## S E R V I C E N O T E

**HP MODEL 8568A SPECTRUM ANALYZER****IF Section Serial Prefix 1928A and Below****MODIFICATION TO IMPROVE MAGNETIC SUSCEPTIBILITY OF DISPLAY**

*Figure 1.*

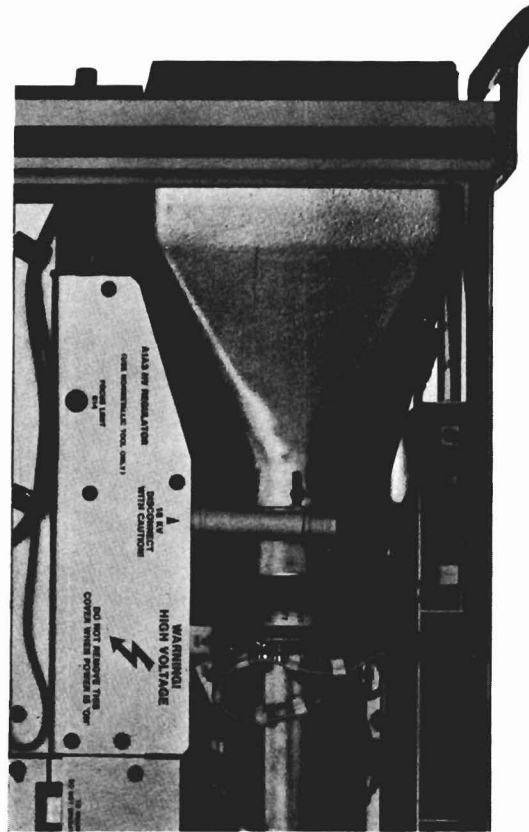
7. Insert the CRT part way into the mainframe and fit the front panel Bezel onto the shield. The fit is quite tight but the CRT and shield must push completely into the Bezel.
8. Finish the installation according to the instructions in the Operating and Service Manual, Figures 8-7 and 8-8. See Figure 1.
9. Verify that the trace align and trace orthogonality are acceptable. If not, make adjustments as outlined under step 5 of this procedure.
